TECHNICAL INSTRUCTION NO. 95

SLINGSBY T65A, T65D VEGA GLIDER

AILERON/WING VIBRATION OF  
T65A and T65D VEGA GLIDERS

Fig. 1 TYPICAL BALANCE JIG

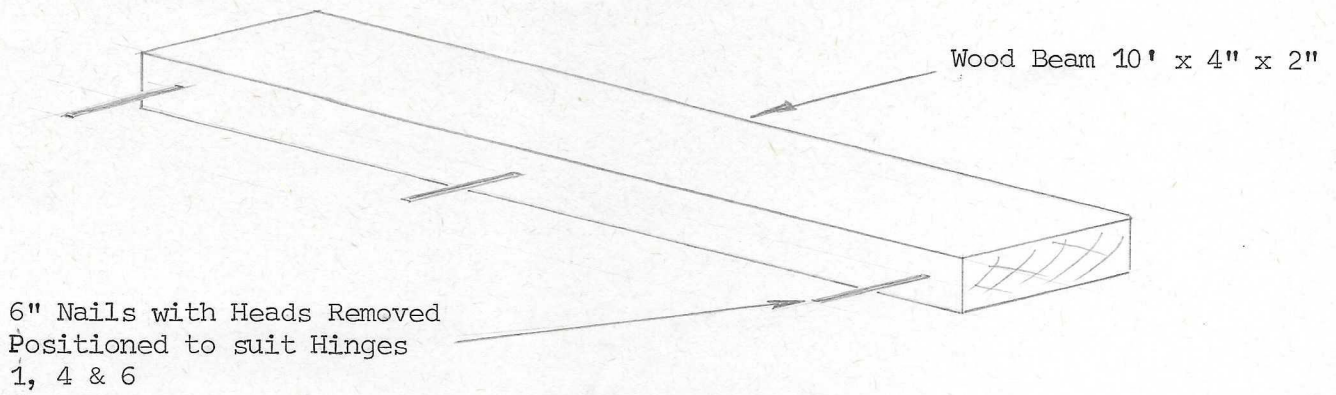
2. Determine the out of balance moment of each aileron as follows:
  - a) Support the aileron at hinge positions 1, 4 & 6 (numbered from aileron inboard hinge) on locally produced jig Ref Fig.1.
  - b) Calculate out of balance as detailed below:

NB Take measurements at the actuator position.

$P$  = load required to hold aileron level, i.e. spring balance reading.

$a$  = distance from hinge line at the point where load "P" was measured.

OUT OF BALANCE MOMENT =  $P \times a$ .

Fig.2 LEAD ADDITION TO AILERON BEAK

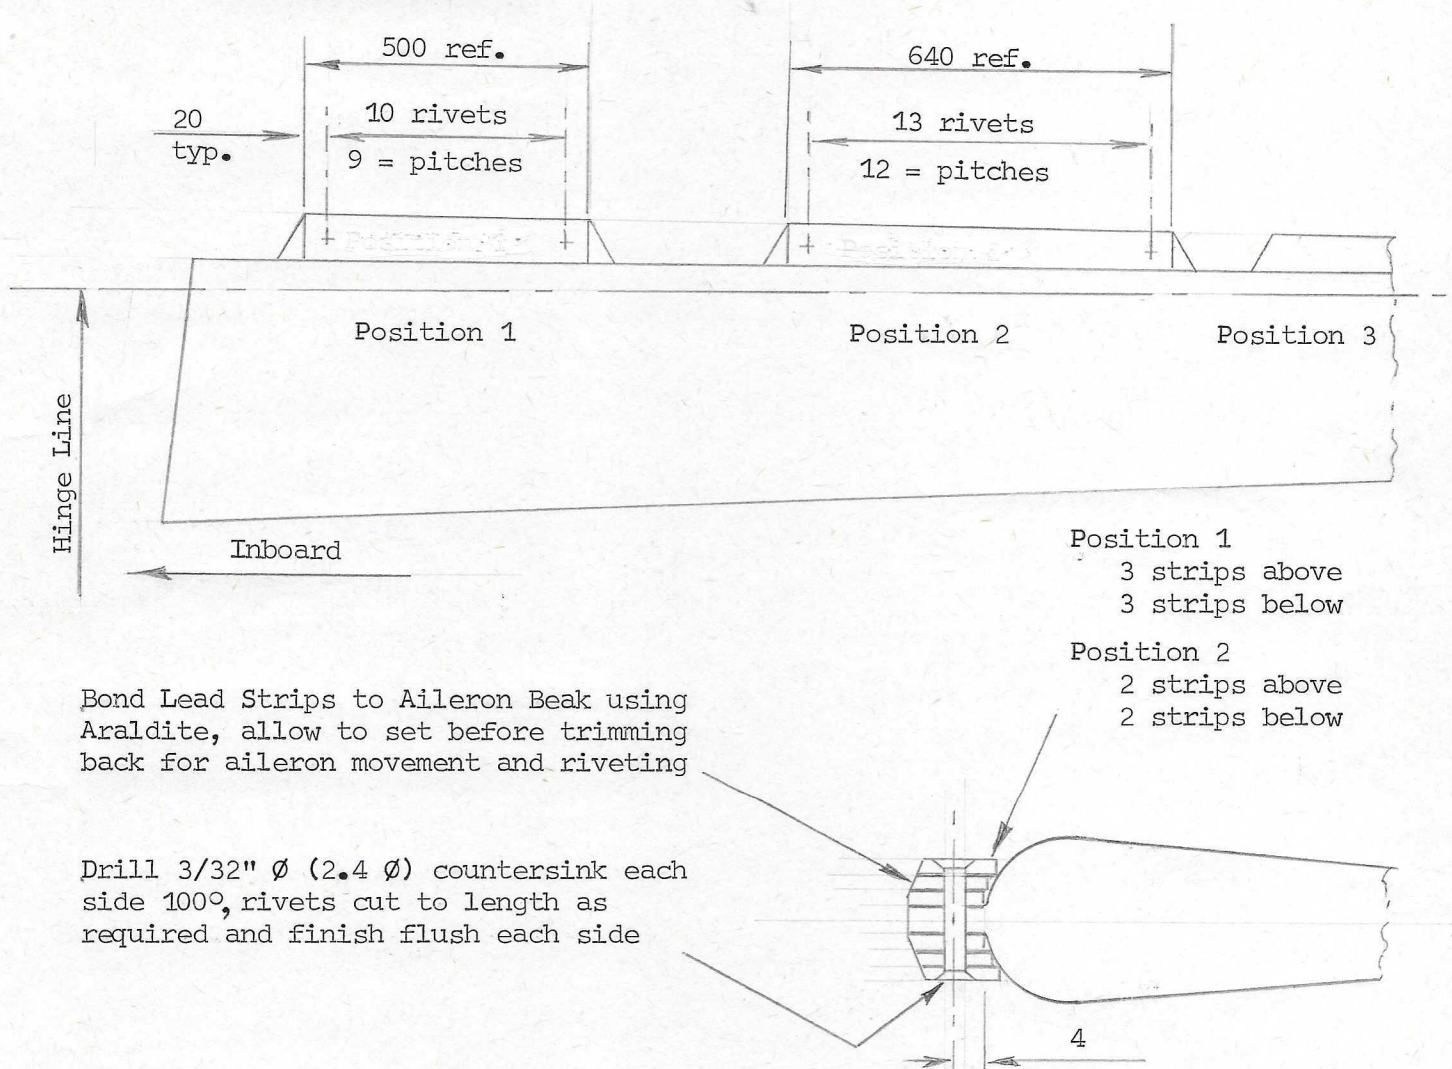
3. Record the actual weight and out of balance moment for each aileron (Ref. Para 7.)
4. From the out of balance moment for each aileron calculate the required amount of lead needed to reduce the out of balance to 3.0 lbs ins and add lead to the aileron beaks as detailed on Fig. 2.
5. Check out of balance moment as in Para. 2.
6. Temporarily fit ailerons and check maximum movements.

Note: At Position 3 '1' lead strip above and below may be added. Minimise length and attach as detailed above to inboard portion of Aileron Beak.

Aileron out of balance not to exceed 3.0 lbs ins (35 kg mm). To achieve this approximately 2 lbs (0.9 kg) of lead has to be added to the leading edge beaks of each aileron.
